PHASE 2 SUBSTATIONS - NORTH TRUCKEE**Complete Civil Construction**

See Master Response 1 for more information on the potential for relocation of the Tahoe City Substation.

SITE PLAN

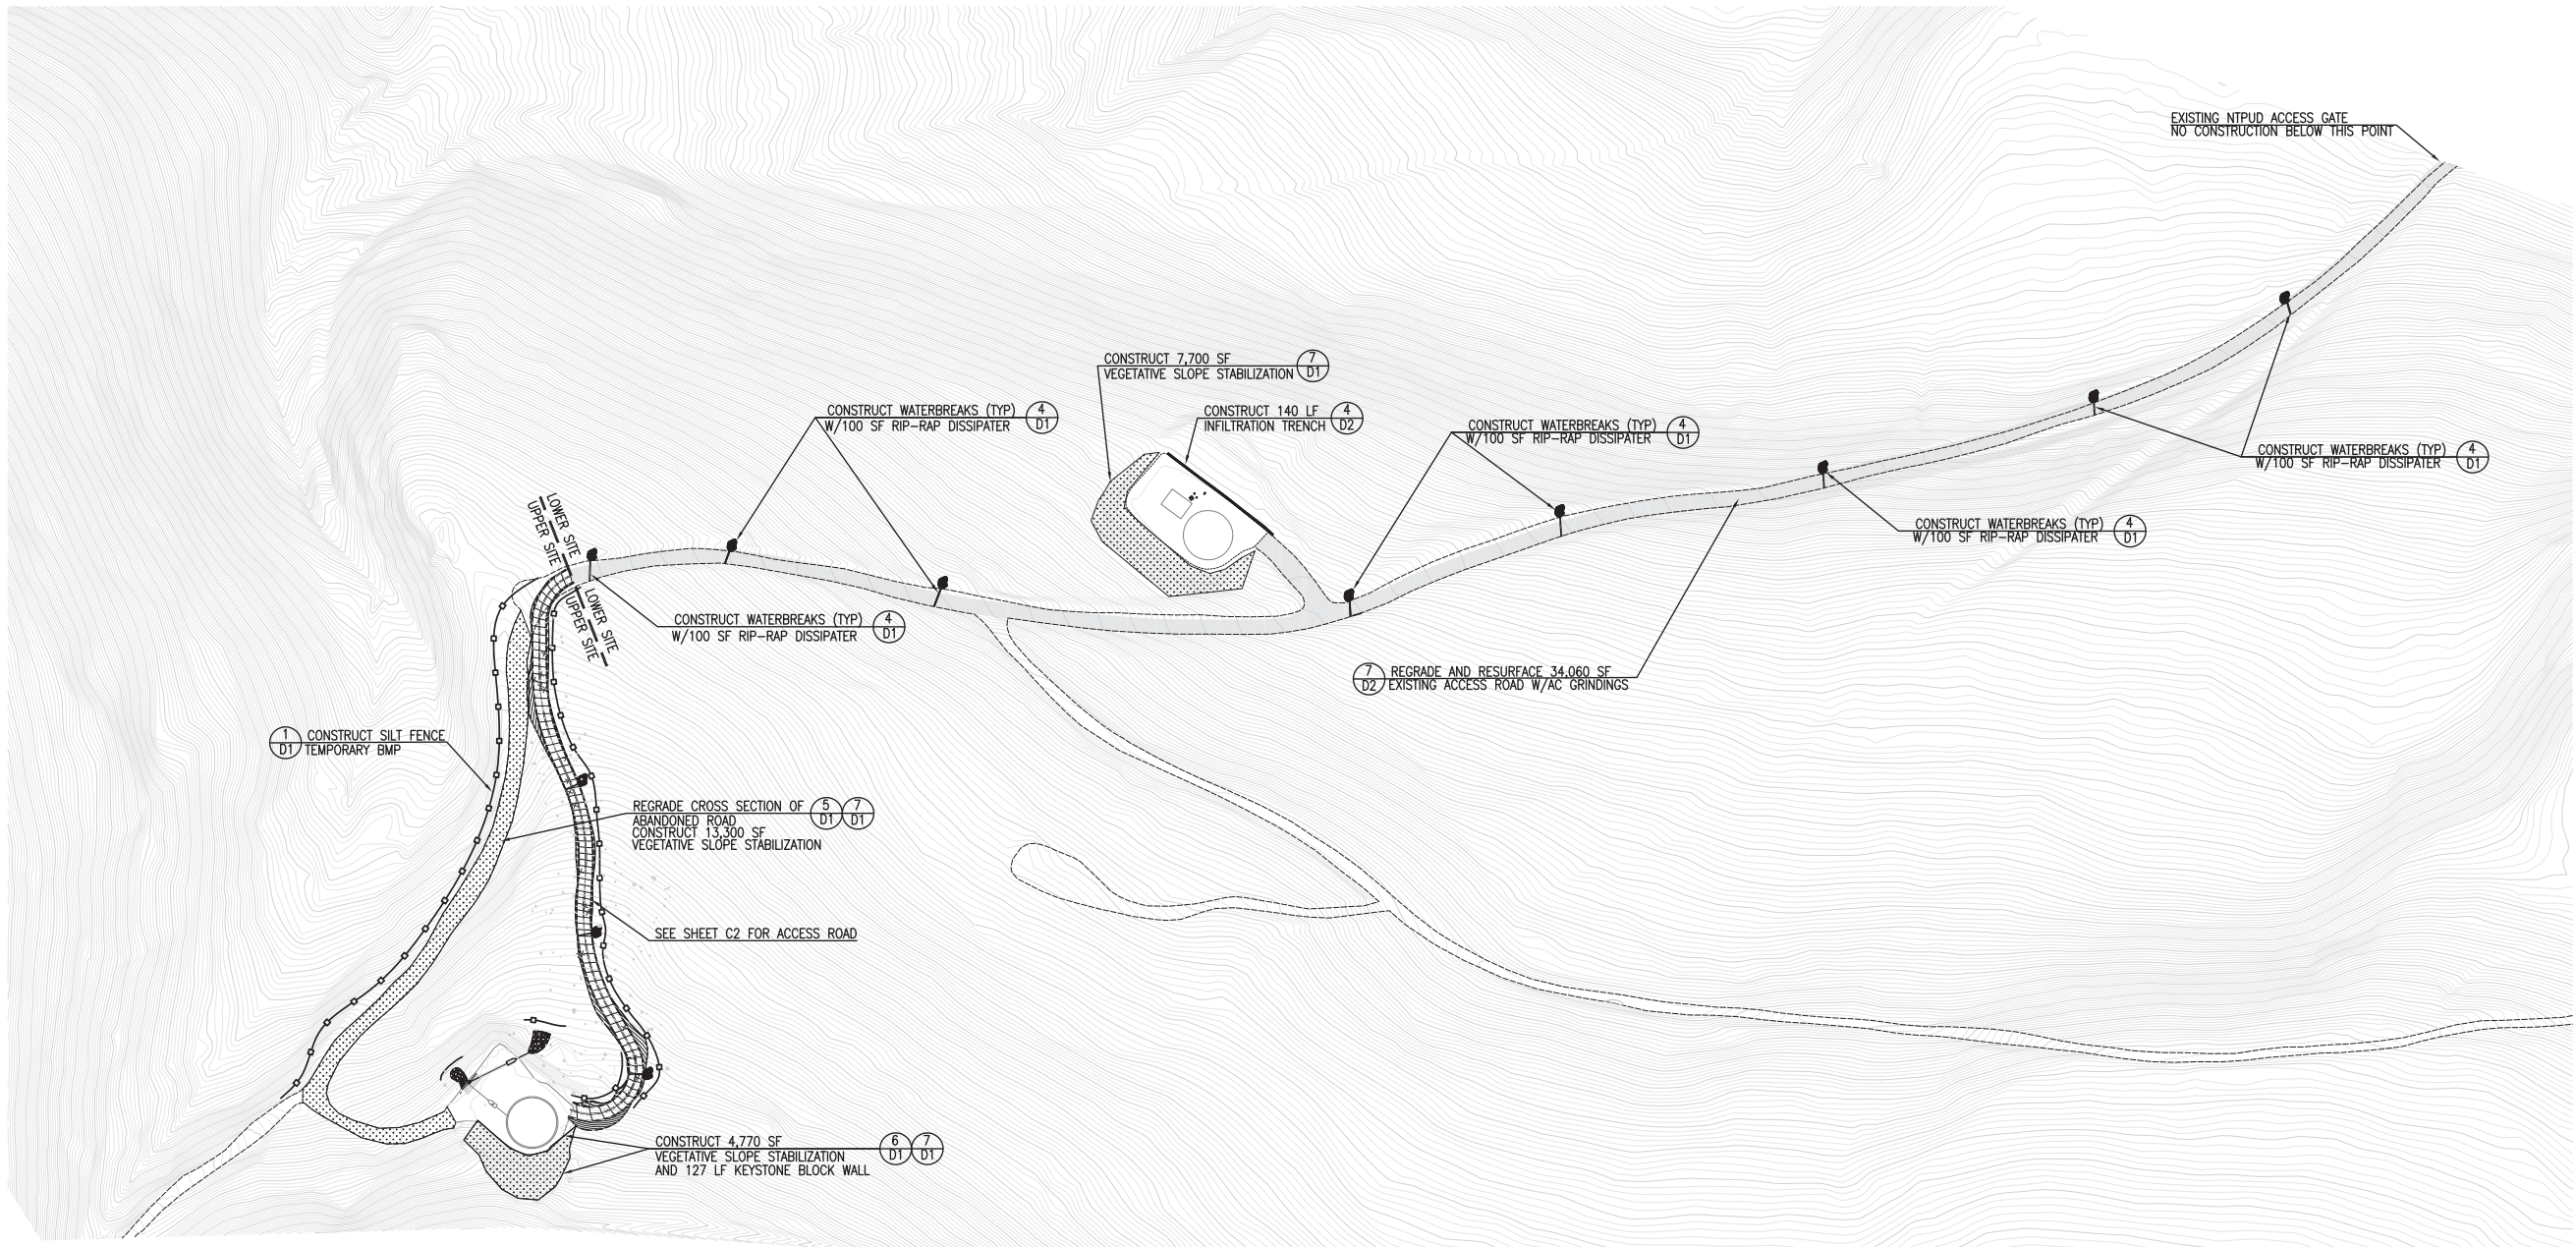
Also, as you will see on the attached 95% plans, sheet C2, the NTPUD is proposing to construct some improvements and reroute the upper section of T16N75.2 on Conservancy lands because it has direct hydrologic connectivity to Carnelian Creek. The Biological and Cultural surveys have been completed and the NTPUD Board of Directors adopted the MND for our project on December 10, 2013. The Conservancy will be granting additional easements to the NTPUD for BMP maintenance as early as their March 2014 CTC Board meeting.
